Cush Wind Farm

## Annex 13.1: Road Safety Audit

Cush Wind Farm, Co. Offaly

Stage 1 Road Safety Audit

Figure 2.1 – Construction Site Entrance Stagger

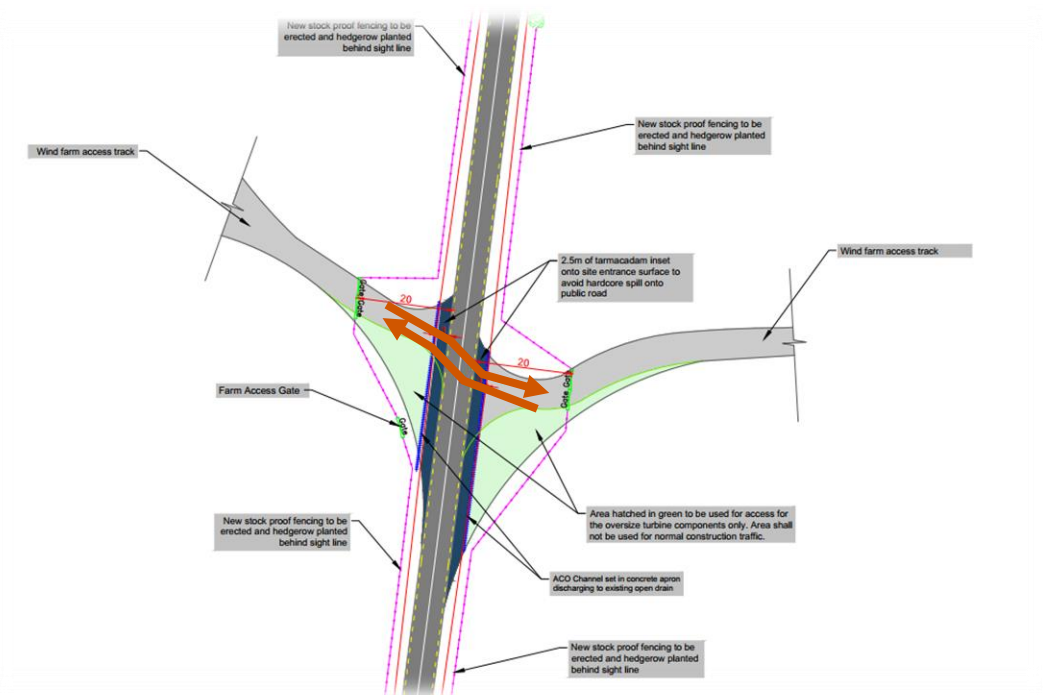
### 2.2 Problem: Opposition Conflict between Entrances

Location: Temporary Construction Site Entrances

The partial stagger setup of the construction site entrances may increase the risk of the occurrence of opposition conflicts between the traffic streams at the entrances.

The stagger of the construction site entrances should be increased or alternatively the entrance be fully aligned.

2.2	YES	YES	The eastern entrance shall be shifted north so that entrances are fully aligned.	
2.3	YES	YES	The access tracks to be constructed so that the first 20meters will have a maximum gradient of 1%.

Figure 2.2 – Construction Site Access Track Approach Gradient

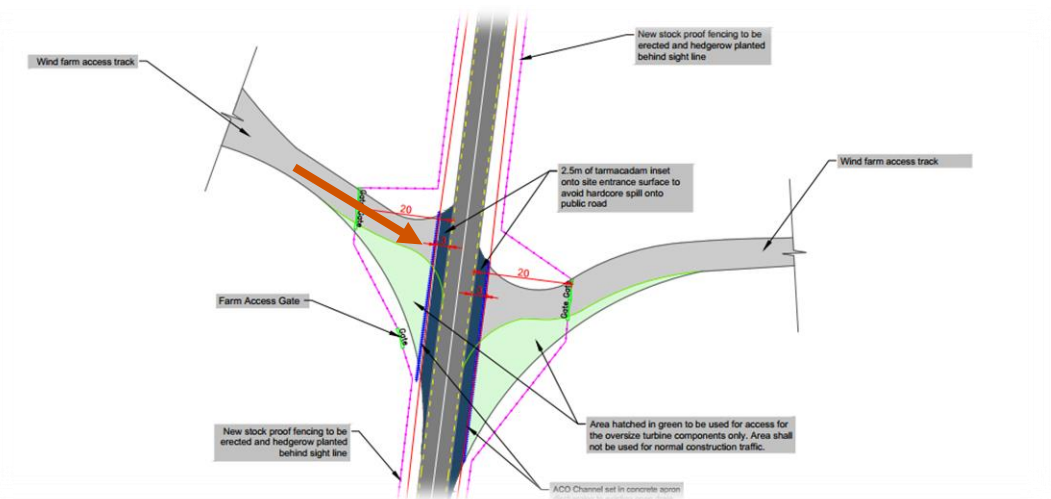
## 2.3 Problem: Step Approach Gradients

Location: Temporary Construction Site Entrances

A steep existing approach gradient on the western construction access track may lead to vehicle stalls on the mainline or vehicles over-shooting the junction onto the mainline resulting in vehicle conflicts.

An appropriate dwell area should be provided on the construction access track approach to the mainline.

Figure 2.3 – Granular Material / Detritus Deposited on Carriageway

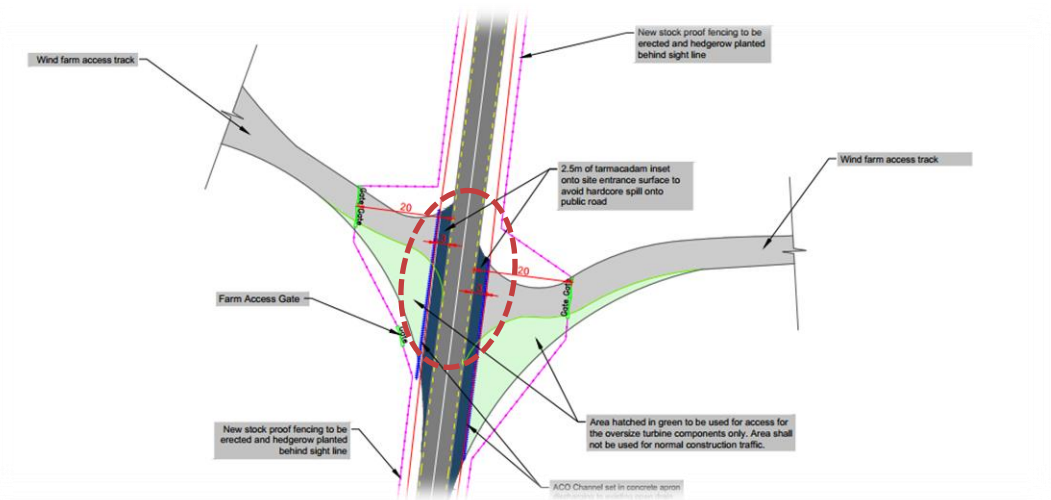
## 2.4 Problem: Material / Detritus Deposited on Carriageway

Location: Temporary Construction Site Entrances

Granular material / detritus from construction vehicles wheels may be deposited on the mainline carriageway impacting the safe operation of the national road.

A suitable wheel washing facility should be provided to serve each of the construction site entrances.

2.4	YES	YES	A suitable wheel washing facility will be provided to serve each of the construction site entrances	
2.5	YES	YES	The pavement on the existing private road should will made good and maintained.

Figure 2.5 – Forward Visibility

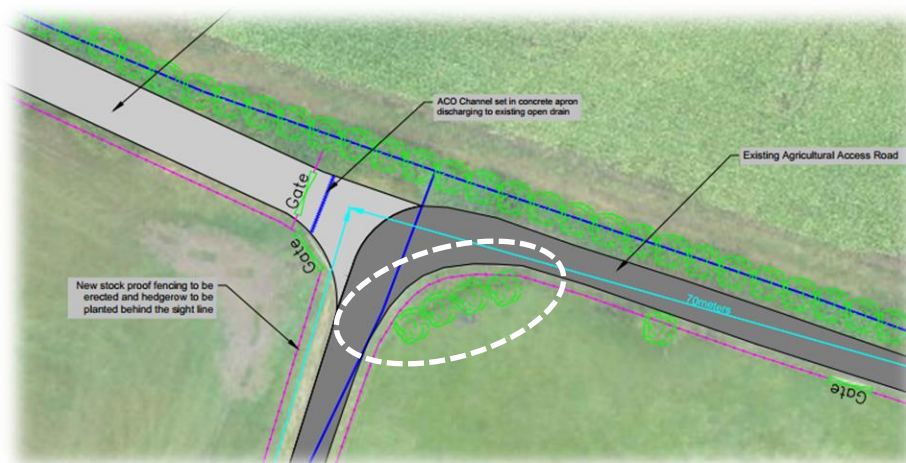
## 2.6 Problem: Forward Visibility

Location: Operational Site Entrance (East)

The overgrown hedge at the bend on the private road may lead to forward visibility impact from the operational site entrance and the private road leading to vehicle conflicts.

The overgrown hedge on the private road should be lowered and maintained to ensure appropriate forward visibility is provided at the bend.

2.6	YES	YES	The overgrown hedge on the local road will be lowered and maintained to ensure appropriate forward visibility is provided at the bend.	
2.7	YES	YES	The entrance gates will be in-set an appropriate distance to ensure that the largest expected size operational vehicle can pull in completely off the local road.

Figure 2.6 – Vehicles Blocking Road

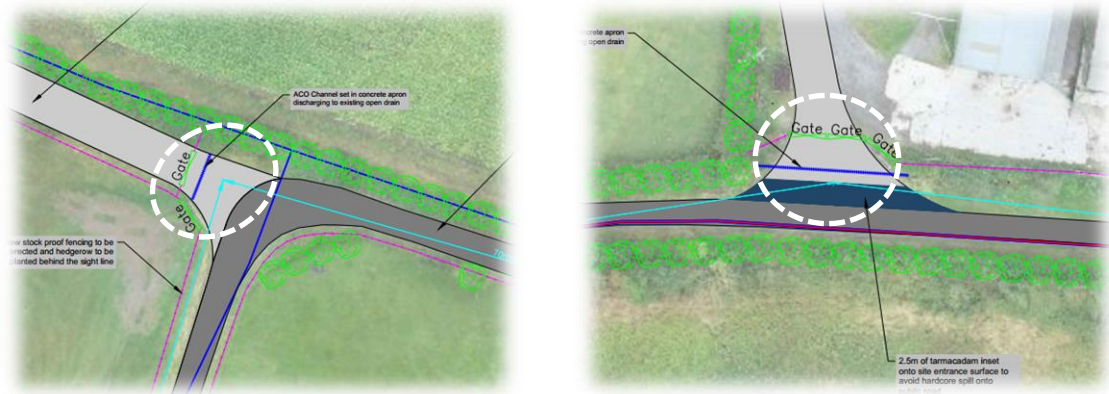
## 2.7 Problem: Vehicle Blocking Local Road

Location: Operational Site Entrance (East) & Operational Site Entrance (West)

The gate setback may not be sufficient for large operational vehicles to pull in completely off the road leading to conflicts with approaching vehicles.

The gates should be in-set an appropriate distance to ensure that the largest expected size operational vehicle can pull in completely off the road.
